## POLICY REPORT DEVELOPMENT AND BUILDING

Report Date: February 26, 2013  
Contact: Kent Munro  
Contact No.: 604.873.7135  
RTS No.: 10000  
VanRIMS No.: 08-2000-20  
Meeting Date: March 12, 2013

TO: Vancouver City Council  
FROM: General Manager of Planning and Development Services  
SUBJECT: CD-1 Rezoning: 2220 Kingsway

Diagram 1

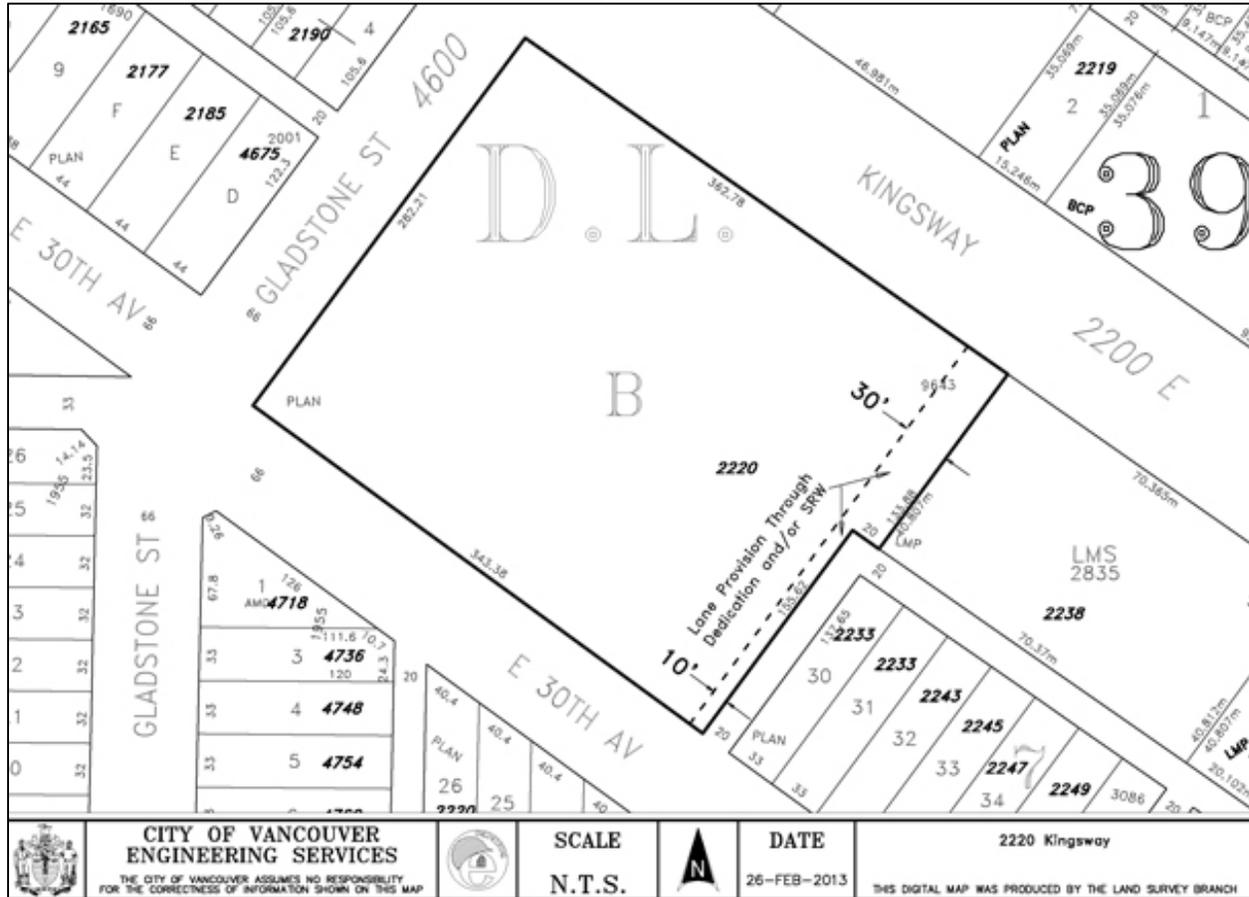
1. Creation of a 30foot wide lane along the eastern edge of the site for vehicular access and to provide a pedestrian corridor and connection from Kingsway to East 30th Avenue through provision of dedications or through other means acceptable to the General Manager of Engineering Services and the Director of Legal Services. See Diagram 1, below.
